T10/1711-D

Revision 08
17 January 2006

Information technology - SCSI / ATA Translation (SAT)

Summary of Comments on SCSI / ATA Translation Standard

Figure 1 — SCSI document relationships

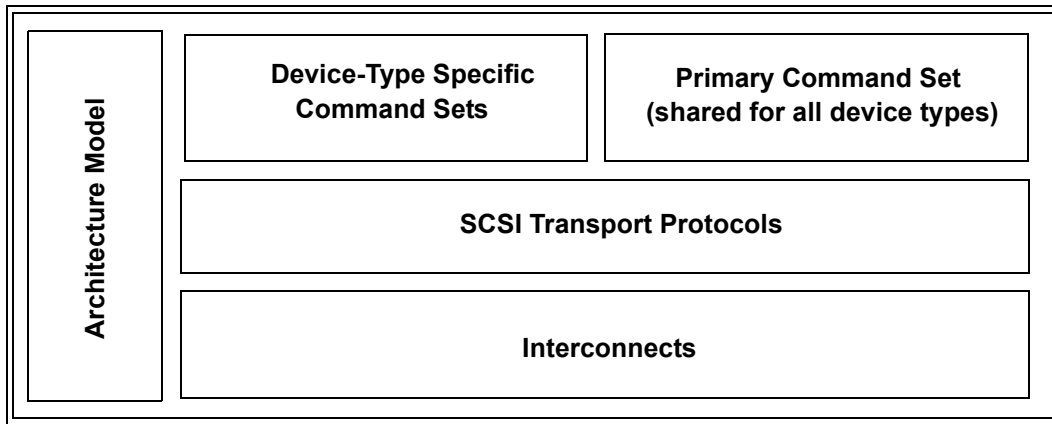
T first sentence after figure 1
This statement is obsolete and should be changed to something like << The term SCSI is used wherever it is not necessary to distinguish between the different SCSI standards.>>

Figure 2 — ATA document structure

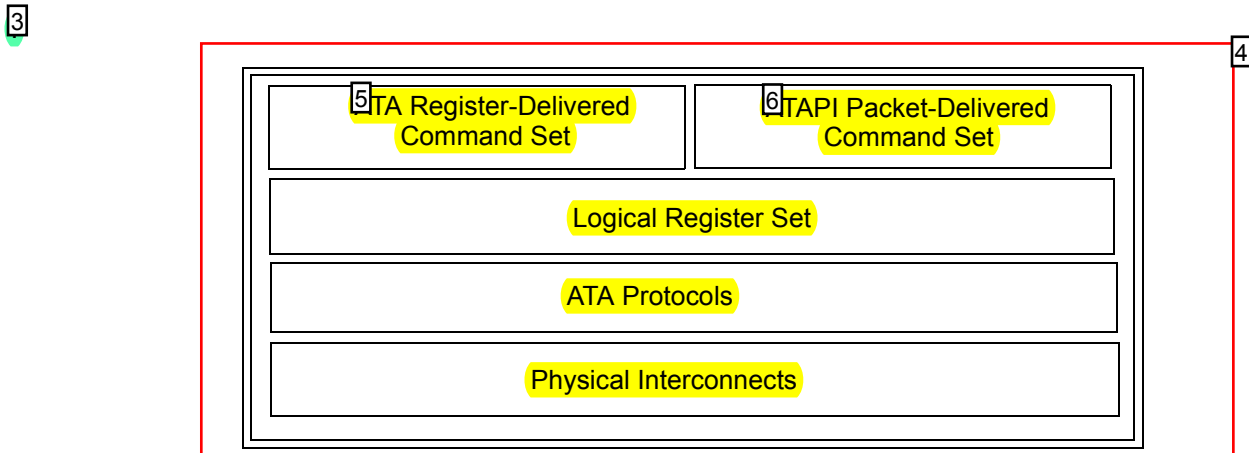
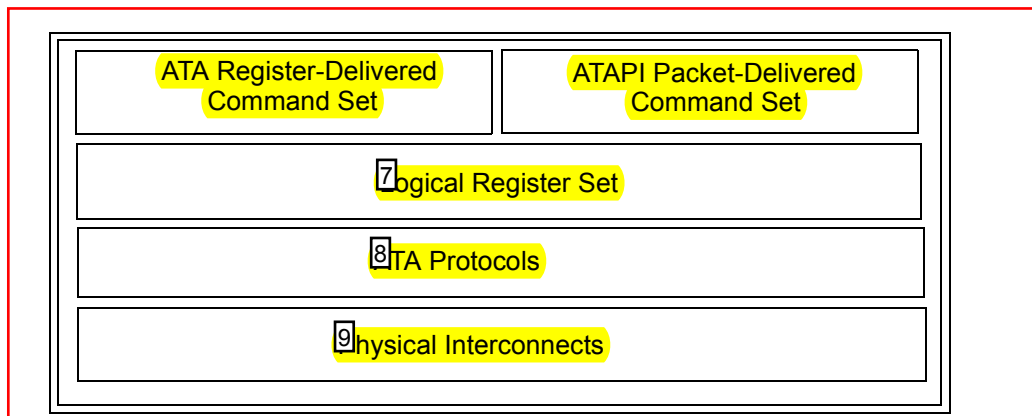
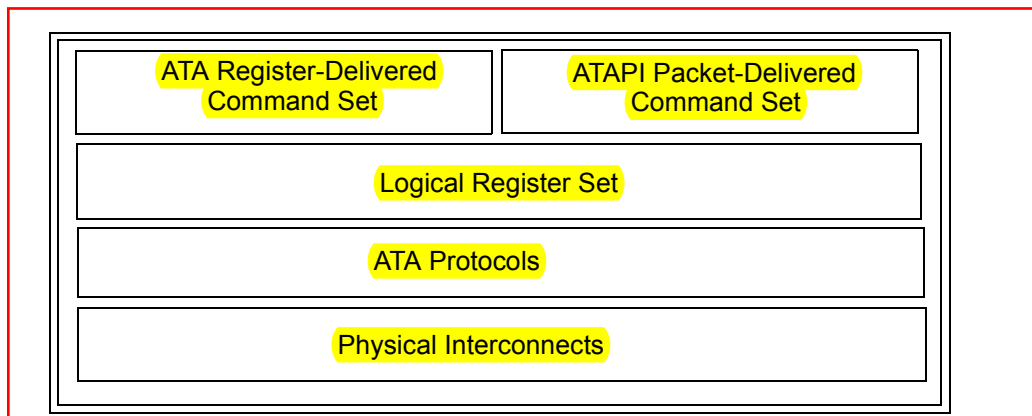
T 1 Scope, the line just before figure-2
Change "ATA/ATAPI-7" to "ATA8".

T Remove the period below the words "Figure 2 shows ..." and above the actual Figure 2.

Figure-2 - ATA document structure
Replace this figure with one showing the ATA8 documents as follows (ignore italics):
"ATA AT Attachment-8 ATA/ATAPI Command Set (ATA8-ACS)
Archi- AT Attachment-8 AT Attachment-8 Serial ATA
tecture Parallel Transport Serial Transport Revision 2.5
Model (i.e., ATA8-APT) (i.e., ATA8-AST) (i.e., SAT -2.5)
ATA8-AAM)"

*After figure 2, add the text,
"ATA-8 AST and SATA 2.5 provide similar descriptions for an ATA serial transport. Requirements of this standard depend upon the ATA serial transport as defined by SATA 2.5, but not ATA8-AST."*

T In Figure 2
change
"ATA Register-Delivered Command Set"
to
"ATA register delivered command set"

T In Figure 2
change
"ATAPI Packet-Delivered Command Set"
to
"ATAPI packet delivered command set"
RESOLUTION: s/b "ATAPI packet delivered command sets", for consistency with ATA8-ACS.

T This layer doesn't appear in ATA/ATAPI-7
Figure 2
change
"Logical Register Set"
to
"ATA logical register set"
RESOLUTION: Delete the box containing "Logical Register Set" as it doesn't appear in ATA8-ACS.

T Figure 2
change
"ATA Protocols"
to
"ATA Transport Protocols"

T Figure 2
change
"Physical Interconnects"
to
"ATA physical interconnects"

Figure 3 — SCSI/ATA translation document role

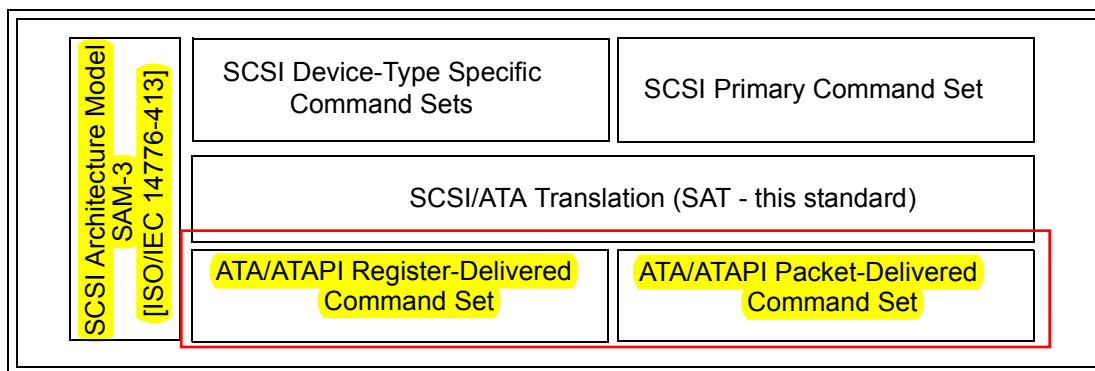
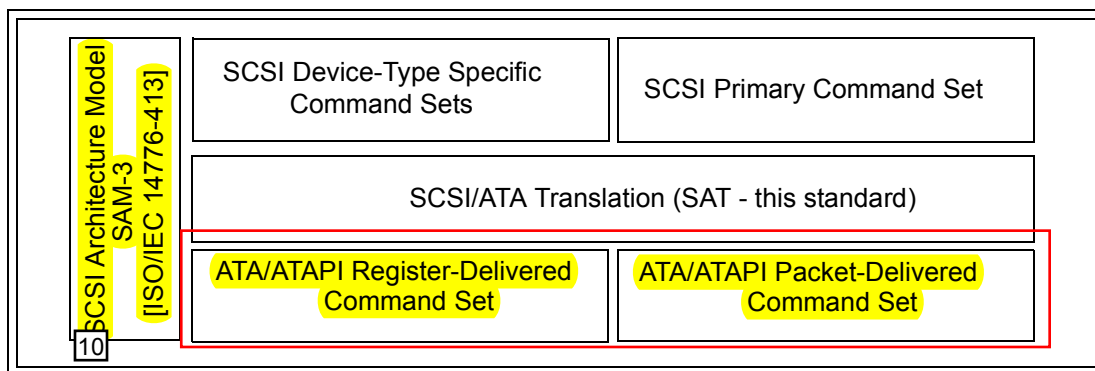
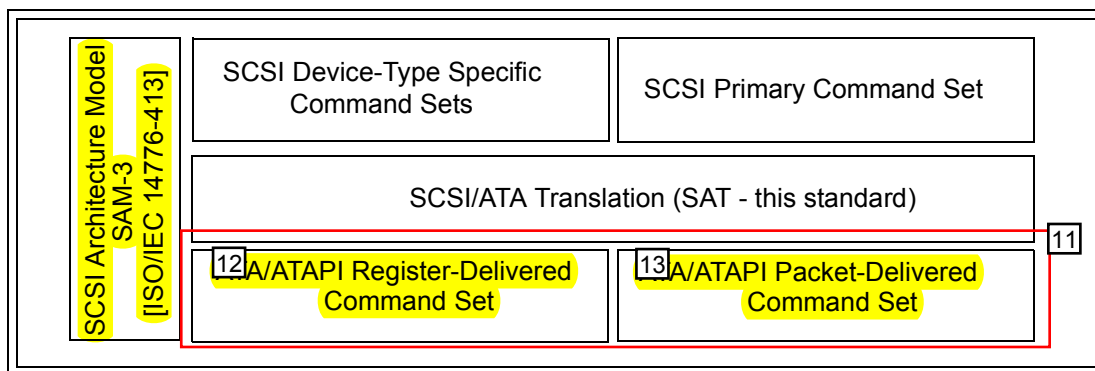
T In Figure 3, remove
"SAM-3
[ISO/IEC 14776-413]"

Figure-3, bottom two boxes:

In Figure 3

In Figure 3

Sequence number: 3
Author: MXO[MEvans]
Subject: Note
Date: 2/14/2006 12:20:03 PM
 1 Scope, after figure 3: delete the blank page in the pdf (i.e., page 23).

Sequence number: 5
Author: DELL[KMarks]
Subject: Note
Date: 1/19/2006 8:52:47 PM
 Remove blank page after Figure 3.

Figure 4 — SAT functional protocol reference model

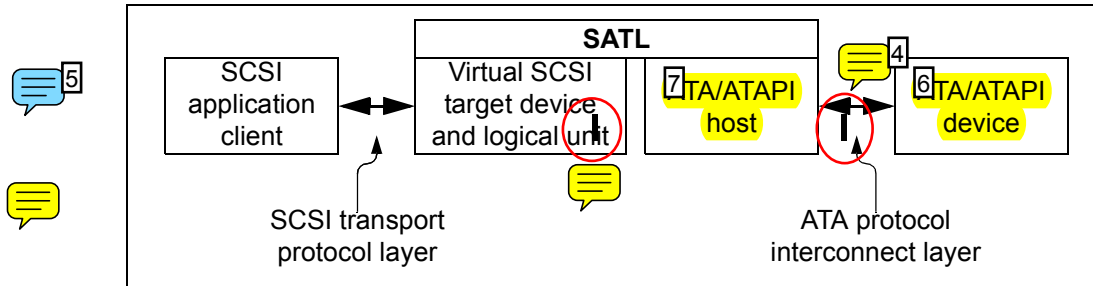
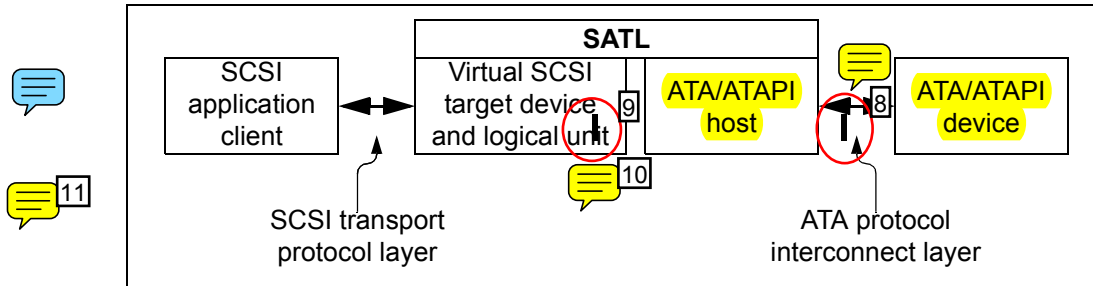
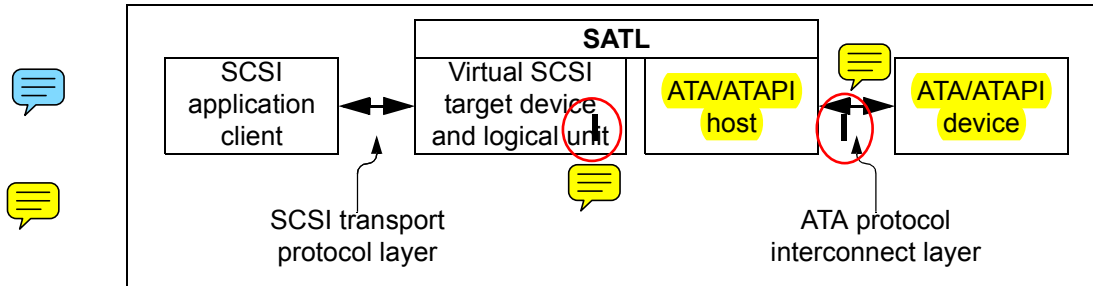
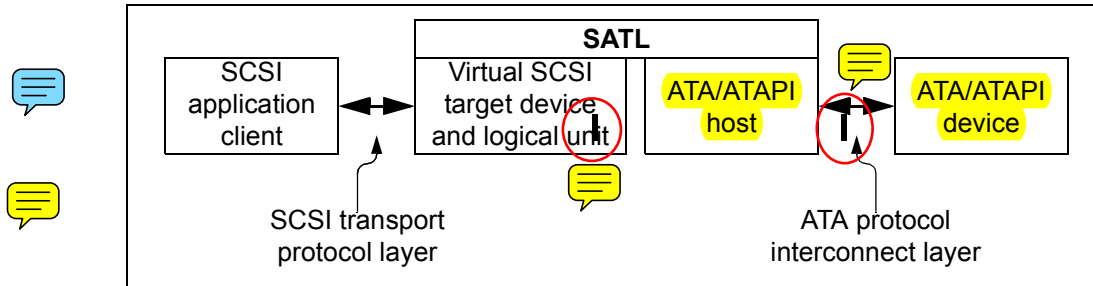
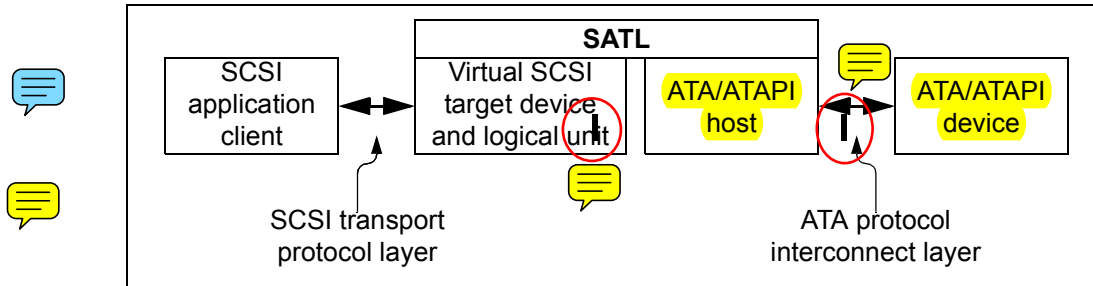
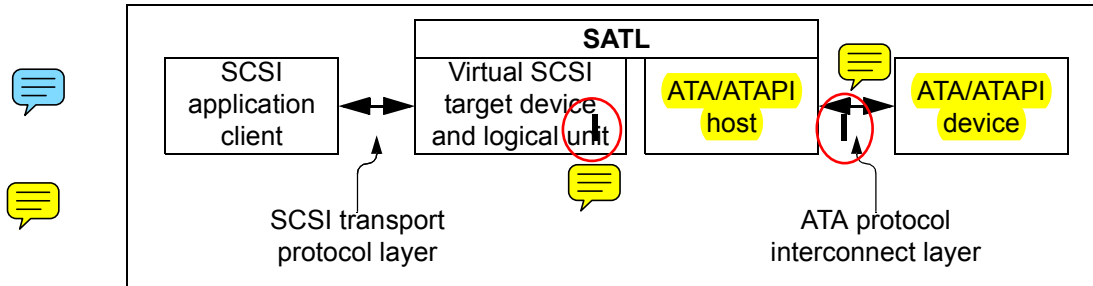
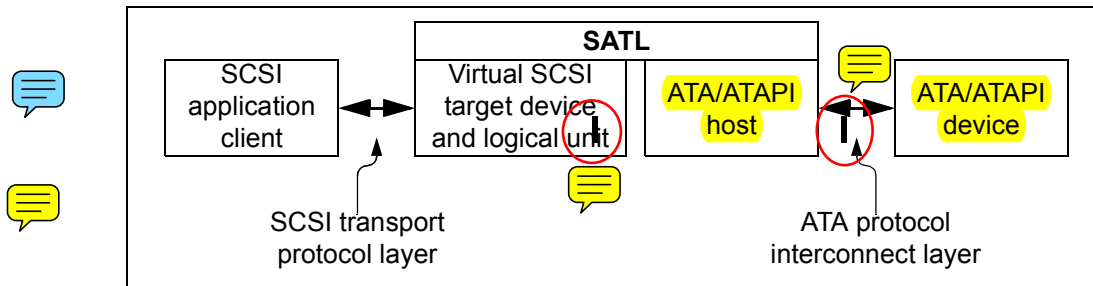
T 5.1 [SCSI architectural elements] Overview, first paragraph: change to, "Clause 5 defines SCSI/ATA translation elements that impact the representation of the storage domains defined in SAM-3 and ATA8-AAM. Figure 4 shows a SATL connecting a SCSI application client to an ATA/ATAPI device.

Figure 4 - SAT functional protocol reference model
change
"ATA/ATAPI host"
to
"ATA host"

5.1
figure 4
remove extra lines in figure

Figure 4
This figure has some strange fat lines in it that need to be removed.

1. Remove what look like change bars in Figure 4
2. Change "logical unit" to "logical unit(s)"
3. Change "ATA protocol interconnect layer" to "ATA transport protocol interconnect layer"

T 5.1 [SCSI architectural elements] Overview, second paragraph: delete the first sentence ("Figure 4 shows a SATL connecting a SCSI application client to an ATA/ATAPI device.") as it is now included in the paragraph before the figure based on the previous comment. Change the remaining sentence to, "The SATL accomplishes this connection by:"

Sequence number: 14
Author: ENDL[RWeber]
Date: 2/14/2006 7:46:55 PM
 1st a,b,c list under figure 4
List entry d) appears to be a regular paragraph, not a list entry.

change to, "Clause 5 defines SCSI / ATA translation elements that impact the representation of the storage domains defined in SAM-3 and ATA8-AAM. Figure 4 shows a SATL providing a communication path between a SCSI application client and an ATA device or an ATAPI device.

Change the figure title to: "Figure 4 - Example of a SATL between a SCSI application client and an ATA or ATAPI device", fix change bars, and the change in item-3 as well.

Figure 5 — Identification descriptors included by a SATL in an ATA host

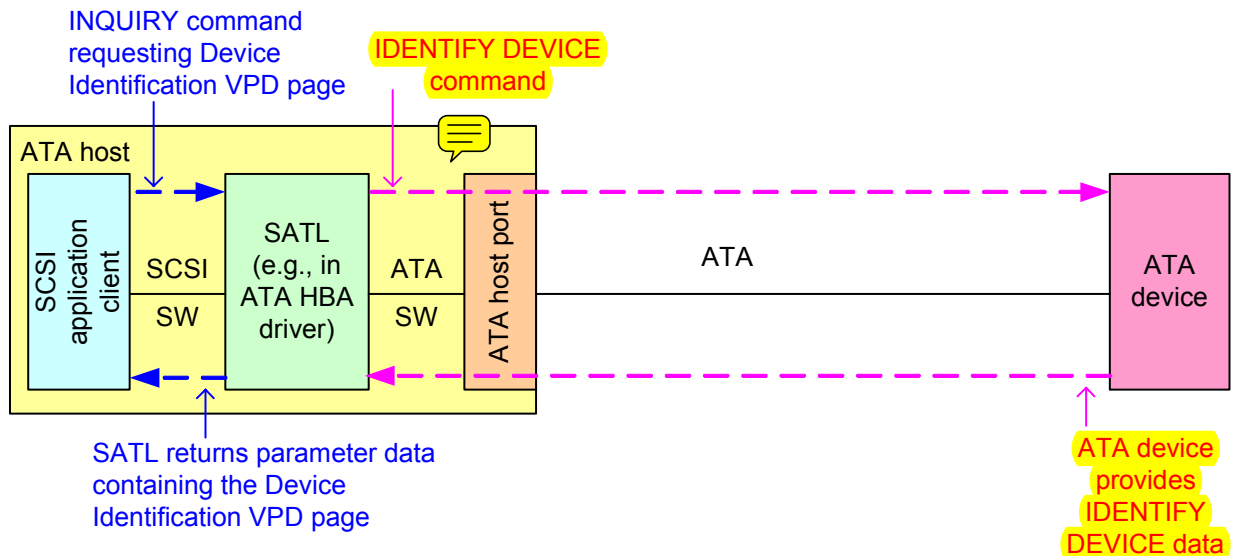
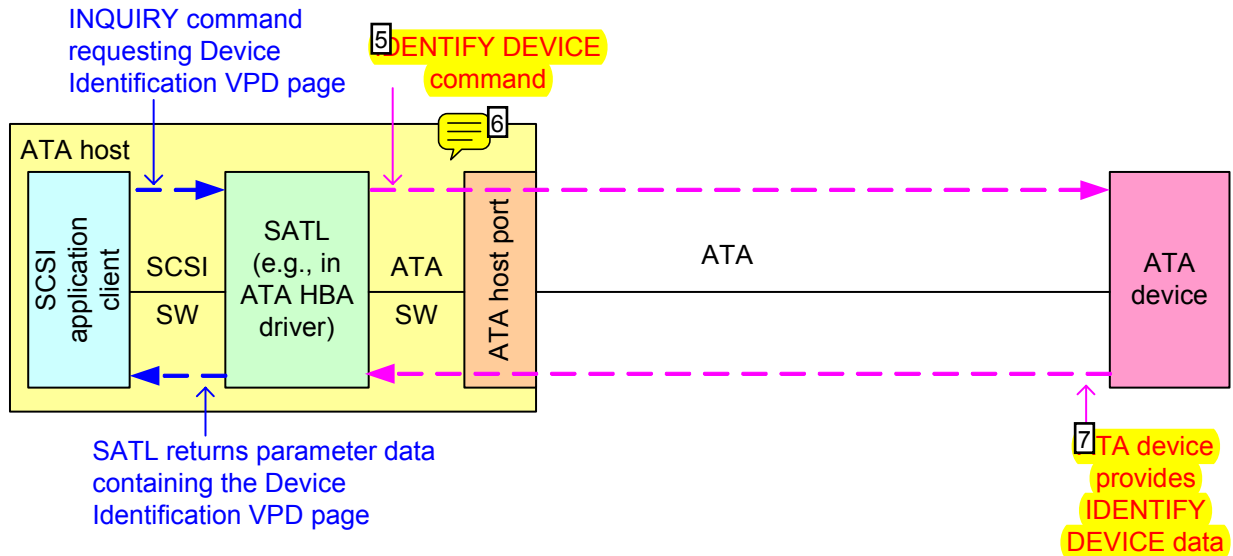
T In **Figure 5 — Identification descriptors included by a SATL in an ATA host**
change
"IDENTIFY DEVICE command"
to
"ATA IDENTIFY DEVICE command"

T In **Figure 5 — Identification descriptors included by a SATL in an ATA host**
change
"ATA device provides IDENTIFY DEVICE data"
to
"ATA device returns ATA IDENTIFY DEVICE data"

Figure 6 — Identification descriptors included by a SATL in a SAS initiator device

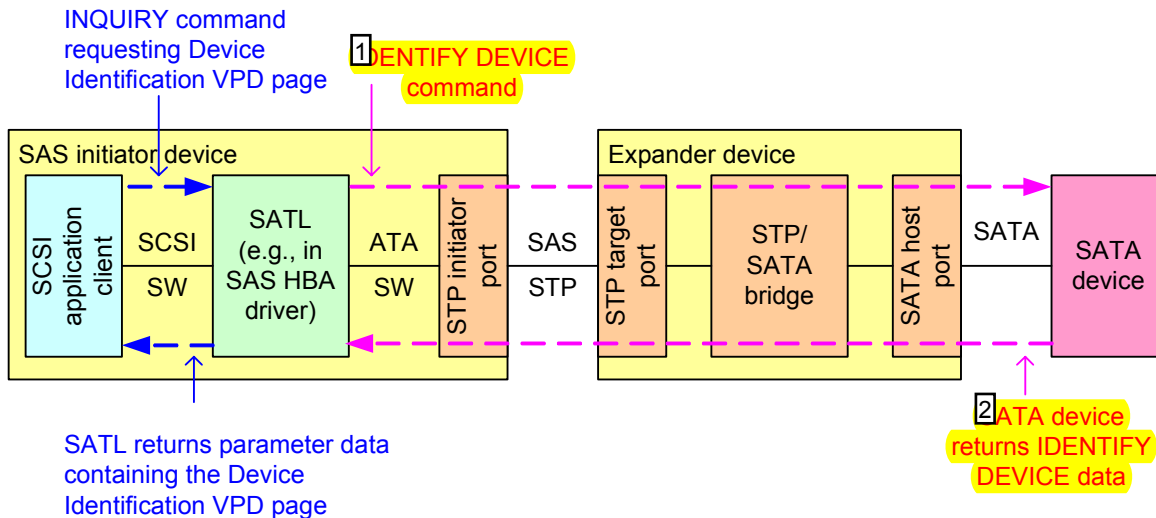
T In **Figure 6 — Identification descriptors included by a SATL in a SAS initiator device**

T In **Figure 6 — Identification descriptors included by a SATL in a SAS initiator device**

Figure 7 — Identification descriptors included by a SATL in a SCSI to ATA protocol bridge

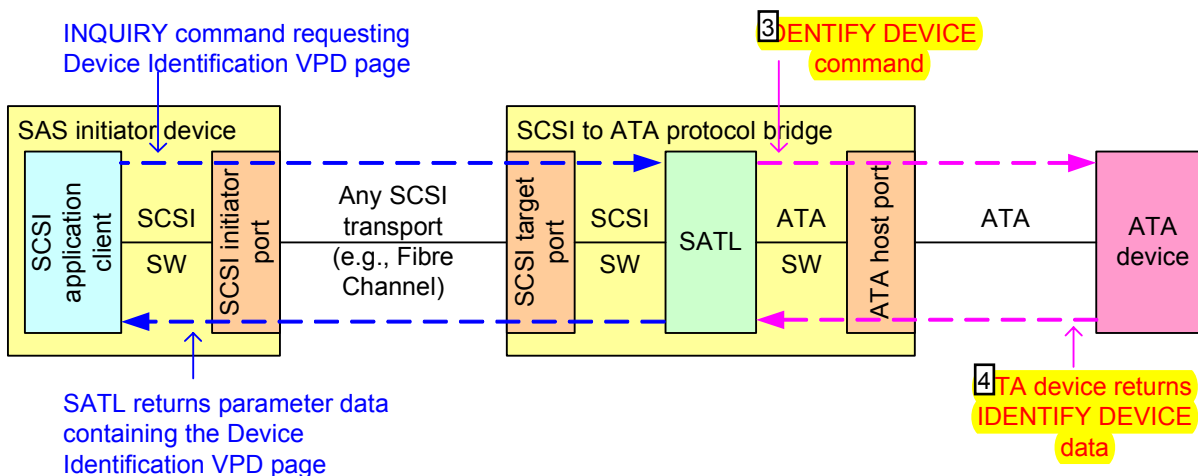
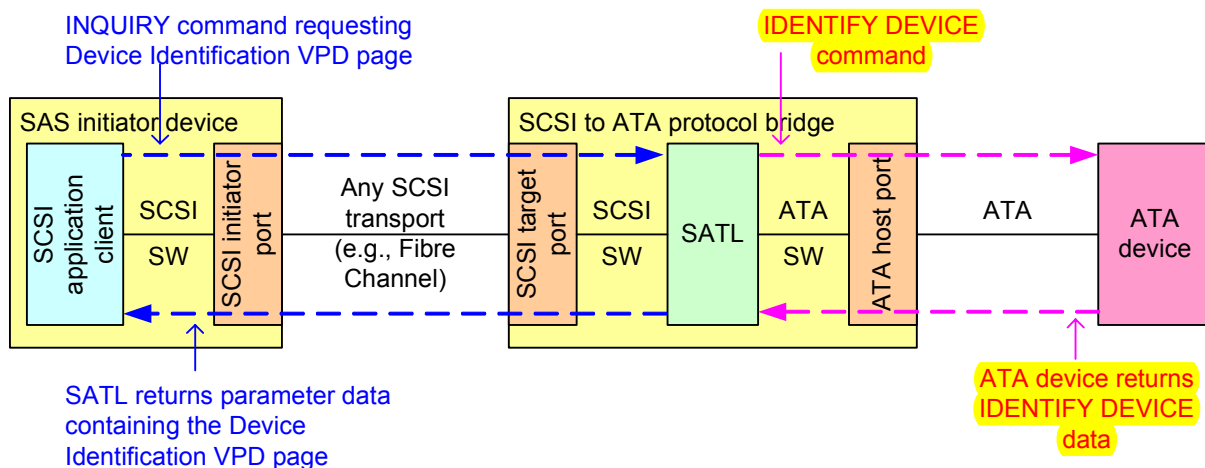
T In **Figure 7 — Identification descriptors included by a SATL in a SCSI to ATA protocol bridge**
change
"IDENTIFY DEVICE command"
to
"ATA IDENTIFY DEVICE command"

T In **Figure 7 — Identification descriptors included by a SATL in a SCSI to ATA protocol bridge**
change
"ATA device returns IDENTIFY DEVICE data"
to
"ATA device returns ATA IDENTIFY DEVICE data"
